Revision of Manuscript Number: IEEE-TPWRS-01391-2021, version 1 January 1, 2022
Journal: IEEE Transactions on Power Systems
Author: Abhishek Halder, Kenneth F. Caluya, Pegah Ojaghi, Xinbo Geng

Response to decision:

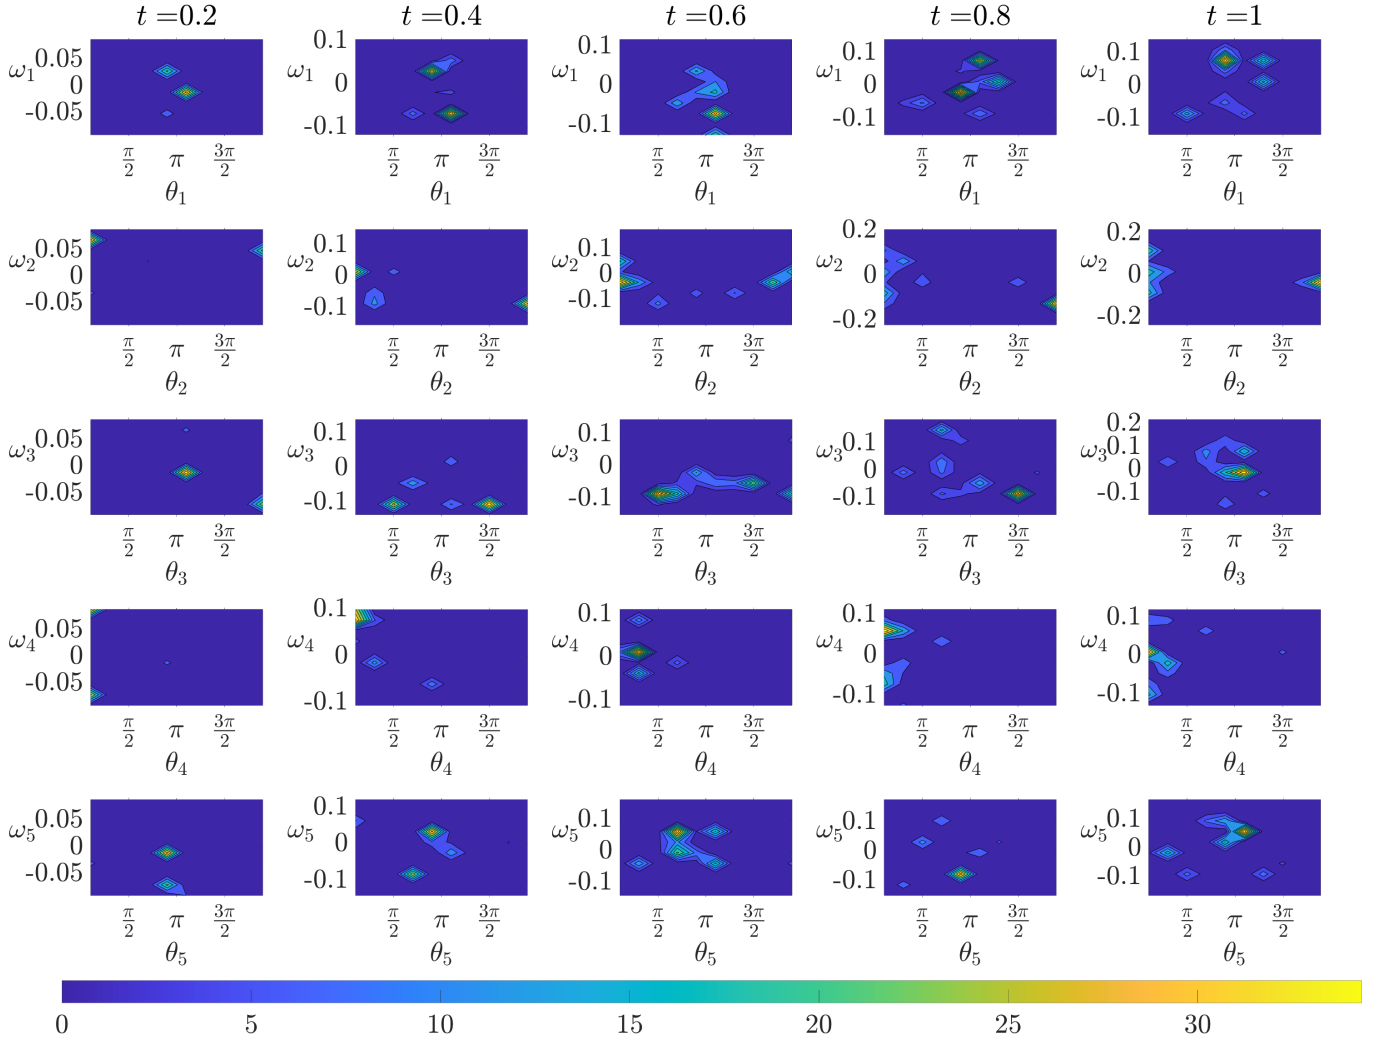
Figures 5 and 6 are unreadable.

Response: Thanks for this comment. In the previous version, the strict 10 page limit enforced small figure sizes. In the revised manuscript, Figures 5 and 6 are made larger. Also, the Fig. 6 in the revised manuscript shows the transient (θ_i, ω_i) bivariate marginals for all the five generators in Case II; the previous version showed the same only for the generator 4 (bus 6). We believe these changes have improved clarity.

Regarding the style of plots, we had considered plotting the bivariate marginals as planar contour plots (as in Fig. 1 in this rebuttal document) but decided against it because of the following two reasons.

First, in our opinion, this kind of plot is scientifically misleading as they hide the fact that these bivariate marginal PDFs are not really supported on the plane, or the subsets thereof, but instead have cylindrical supports. Our message that the proposed method explicitly accounts this manifold geometry in the computation, would be missed had we chosen to make the plots as per populist cognitive bias on behalf of the readers. That the planar plots evoke a sense of familiarity cannot be a scientific argument in favor of it.

Second, the planar contour marginal plots require additional mental efforts from the readers to correctly parse the statistical information conveyed. For instance, consider the fourth column, second row subplot in Fig. 1 in this rebuttal document. It is upon the reader to parse that the two high probability regions on the left and right of that subplot are actually referring to the same angular high probability region around $\theta_2 = 0$, thanks to the periodic boundary condition on the angular variable. Our philosophy of technical communication is that the onus is on the authors, not on the readers, to present the scientific information as correctly as possible. And yes, we are aware that many papers in the power system literature make plots in the rectangular domain ignoring the manifold nature of the support, which in our experience,

continue to add pain to the graduate students and beginning researchers trying to understand the statistical meaning conveyed in those plots. We prefer ours not be contributing to the accrual of such pain, and instead make plots that depict the variables as they are.
